Office Action Summary	Application No. 10/538,968	Applicant(s) VELICANIN, MENSUR	
	Examiner KRISTINA R. FULTON	Art Unit 3673

DETAILED ACTION

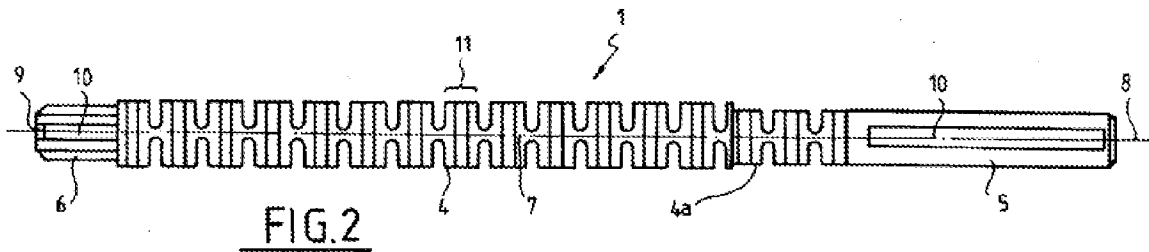
Regarding claim 1, Rovira shows an actuating device for a lock in a door or hatch of a motor vehicle, with a lock cylinder (part of 3), which has a lock (part of 2) located a certain axial distance away and a shaft (1) extending between it and the lock; which shaft transmits a torque to the lock when the lock cylinder is rotated; where the shaft is flexible (figure 1) in its axial direction to compensate for a radial offset between the axis of the lock cylinder and the lock, the one-piece shaft is made of flexible material and has a family of notches (12) extending transversely to the axis of the shaft; which notches are recessed in pairs into the shaft from diametrically opposing sides in that when the shaft is stretched out straight, the two flanks (18, 19) of the notches are essentially parallel to each other and extend radially with respect to the axis of the shaft; the notch pairs leave a web (15) in the shaft between their flanks; which web is located on the axis of the shaft and extends essentially across the entire diameter of the shaft wherein the webs produce flex points, at which, when bending load is exerted on the shaft, the two flanks of the notch pairs can swing toward or away from each other; wherein intermediate axial pieces, extending in the axial direction of the shaft and with the full cross section of the shaft, remain between successive pairs of diametrically opposing notches; and wherein a driver (6) for actuating the lock is formed integrally on the shaft. (Please note that the prior art teaches all of the claimed structural limitations and therefor inherently performs the claimed functional language.)

7. Regarding claim 2, the driver has the form of a paddle (the sides are chamfered like a paddle).

8. Regarding claim 3, "as best understood", wherein an overload element (portion 4a) is integrated into the shaft. See the Rovira device below.
